23. Provide fiber penetration test results and penetration model assumptions that are based on the testing to the extent that the NRC staff can perform confirmatory calculations to validate the in-vessel fiber values used in the analysis.

Ameren Missouri Response:

Figure Q23.1. Cumulative fiber penetration mass from four independent tests.

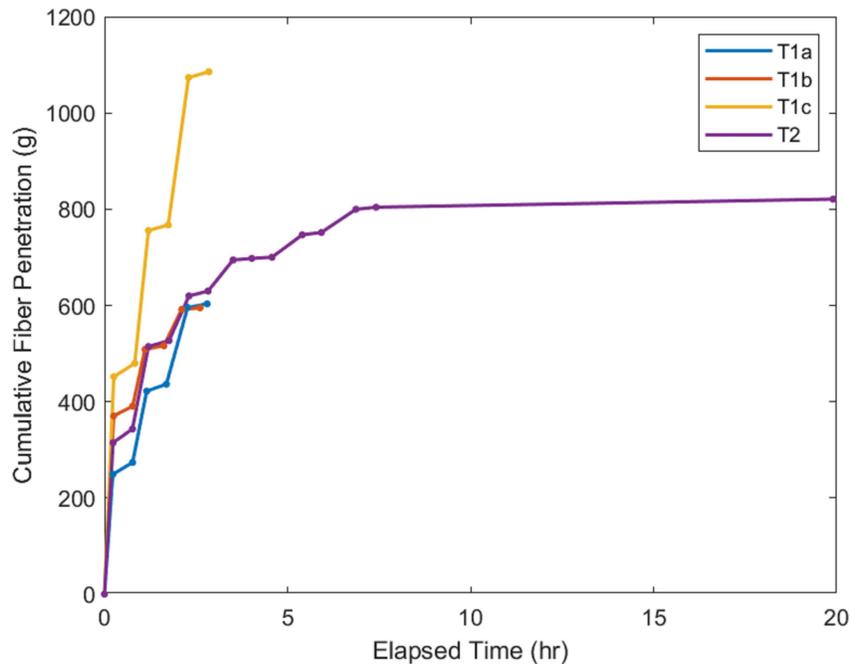
The NRC staff reviewed the fiber penetration test report. The licensee performed three preliminary tests and a final quality assured test (Test 2) to quantify penetration. The NRC staff was unable to confirm that the model used to calculate the amount of penetration at various strainer loads was realistic or conservative compared to the test results. Specifically, the NRC staff identified that Equation A-50 in the strainer penetration test report (ALION-CAL-CEC-9345-003, Rev. 0) underpredicted the amount of fiber penetration when compared to strainer fiber penetration Test 2 data. The licensee stated that equation A-50 was not directly used to calculate the fiber amounts in the core for the submittal, but that the issue would be investigated because Equation A-50 was pertinent for conditions in the tests. Differences between Equation A-50 and Test 2 results may indicate artifacts in estimates of parameters of empirical fiber penetration functions. The licensee will provide information in a supplement that includes details on the method used to calculate the fiber penetration as the strainer fiber loading changes so that the staff can confirm that the values are realistic when compared to the test results.

Figure Q23.1 illustrates cumulative fiber penetration data for all four tests. Although Test 1c and Test 2 used the same solution pH and loading schedule, Test 2 results are fully consistent with Test 1a and Test 1b data, indicating a negligible pH effect on fiber penetration at the tested flow velocity. At all fiber loads, Test 1c cumulative fiber penetration mass lies above the 95th percentile of cumulative fiber penetration mass obtained from the other three tests, indicating a possible anomaly in fiber preparation or test procedure implementation under the exploratory, abbreviated test format. Because the close agreement between Test 1a, Test 1b, and Test 2, is typical of replicates performed under the same test procedure, Test 1c is not considered to represent a realistic fiber penetration result.
